Staff Report

Date: May 7, 2020 (for May 13, 2020 hearing date)
Re: PLNSUB2019-01033 Granary on 9 Planned Development

PLANNED DEVELOPMENT

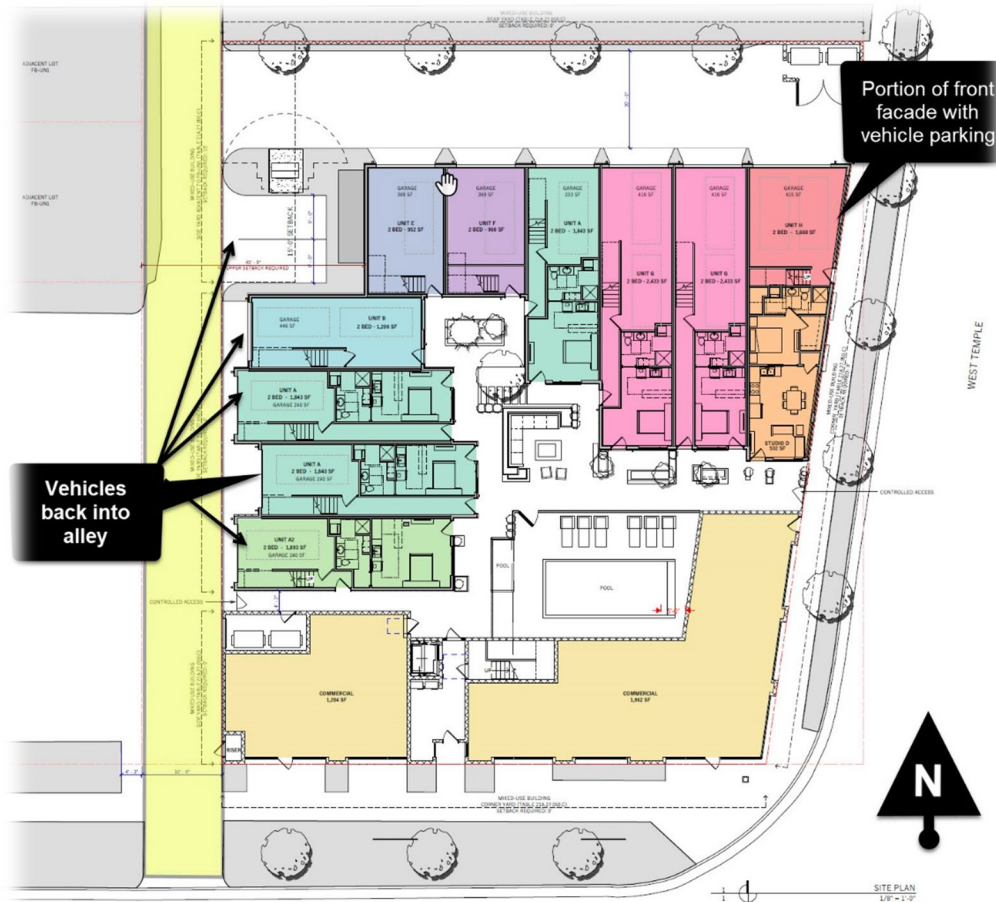
1. Four garages and two surface stalls will back into the alley as they exit. This affects the four units on the west end of Building 2 abutting the alley and two surface stalls adjacent to these units.

Issue 1: Vehicles backing into an alley

The vehicle parking on-site is for the residential uses, via attached garages and two surface stalls, but access to four of 10 garages and the surface stalls would be from an adjacent private alley to the west, as mentioned on the previous page (see image on previous page). The Form Based Urban Neighborhood zone (FB-UN) encourages developments to use the alleys through its zoning standards. These include requirements to use the alley for vehicle access rather than a front yard driveway when alley access is available.

However, per the parking regulation referenced previously, for multi-family uses it prohibits a parking design that would require a vehicle to back into the alley when exiting a parking space. The intent of the parking code restriction is to mitigate the potential for collisions in an alley. Multi-family uses generally have more parking stalls than a single-family use and thus an increased potential for collisions. The proposed parking configuration functions the same as if the residential units were single-family attached, thus the difference between multi-family and single-family in this case is negligible.

When the FB-UN code was written it did not modify this restriction of the zoning code. Only after development started to occur in the FB-UN zone was this limitation noticed. Alley use is an important aspect of the FB-UN zone. The use of the alley for garage access helps activate the alley and reduces its potential for crime or other issues associated with disused alleys. The proposal meets the intent of the FB-UN zone by activating the alley and modification of the zoning restriction results in a more enhanced development than would otherwise be possible. Neither the Transportation division nor the Planning Division has concerns with the configuration of this proposal, although the alley may need to be improved per the assessment of the City Engineering Division (see department comments in [Attachment G](#)).

(East façade, West Temple; building 1 on the left with mural, building 2 to the right of gap)

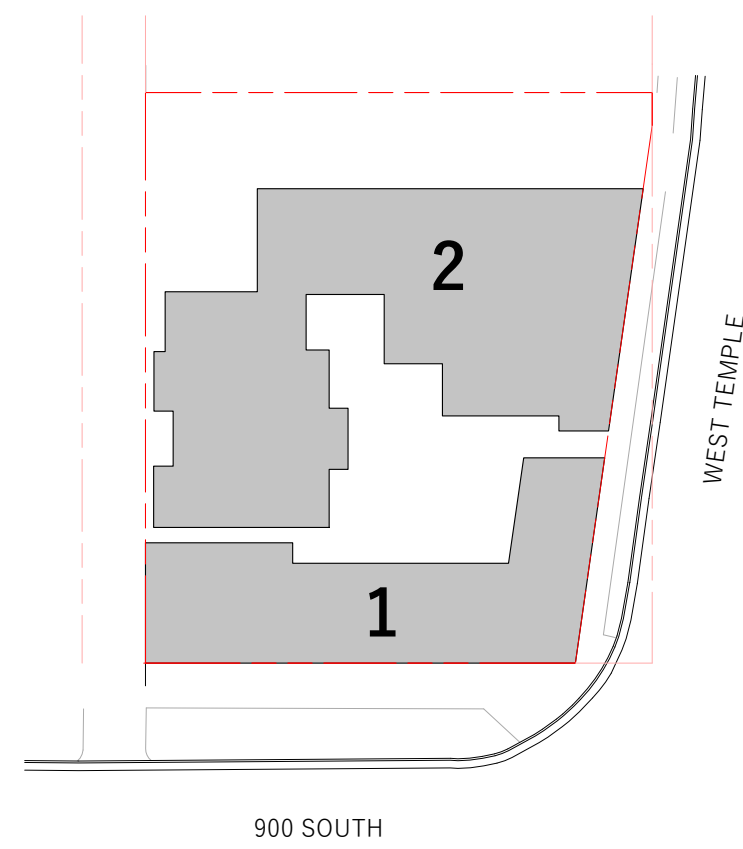
Issue 2: Ground floor use along West Temple

The east façade, along West Temple, has a portion that includes an enclosed garage for one of the residential units (see area noted in red in diagram below). This portion includes two windows to maintain the glazing along the façade for pedestrian interest and avoid a blank wall. The garage is approximately 20 feet long and occupies 33% of the façade length of building 2. The facades of buildings 1 and 2 are considered separate along West Temple.

The total length of the façade is 61 feet, making it difficult to fit a garage for the residential unit directly above and still comply with the ground floor use regulation. The façade is designed with windows and an entrance door into the garage to maintain architectural interest and consistency along the façade while lessening the impact to the ground level view. Planning staff determined the modified design still meets the intent of the ground floor design standard and supports the modification.

3
LEVEL 3 OVERALL PLAN
GRANARY ON 9

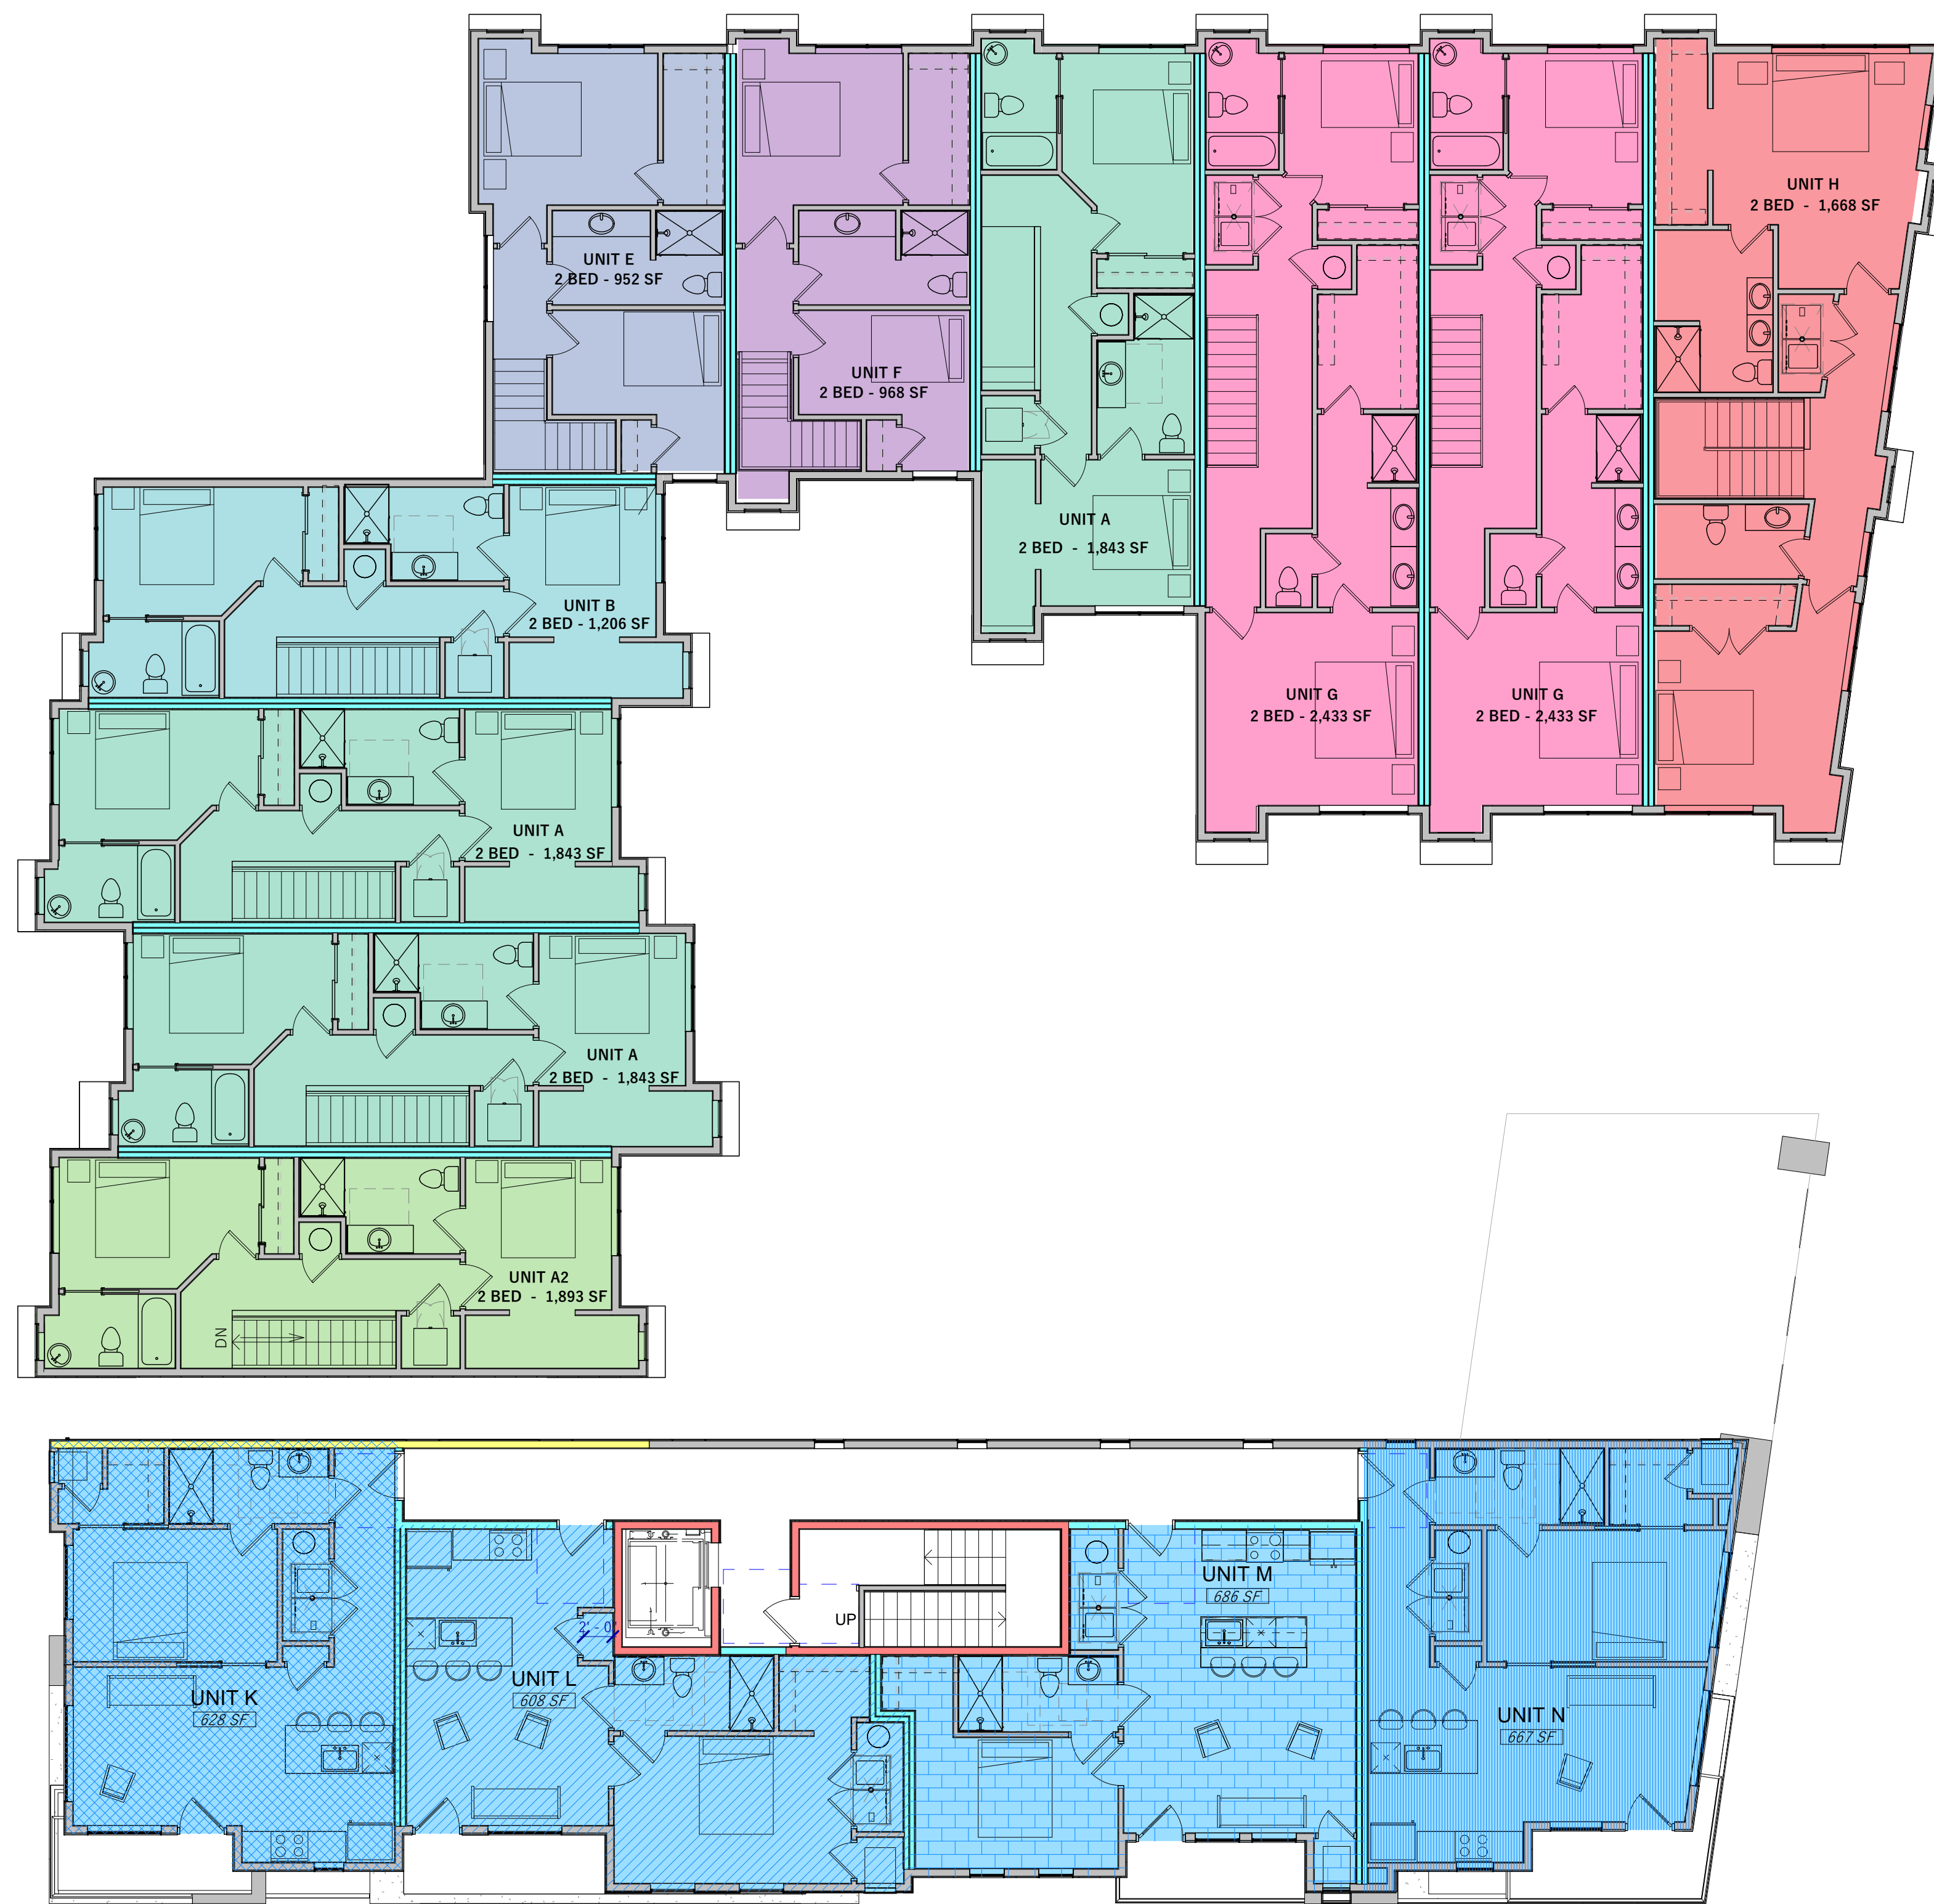
A zoning review correction item about depiction of refuse dumpster on site plan- an opening in wall surrounding refuse and recycling collection is visible, which would not satisfy screening requirements of 21A.48.120, for "all sides" of enclosure, needs to be addressed. **[resolved with gate enclosure]**
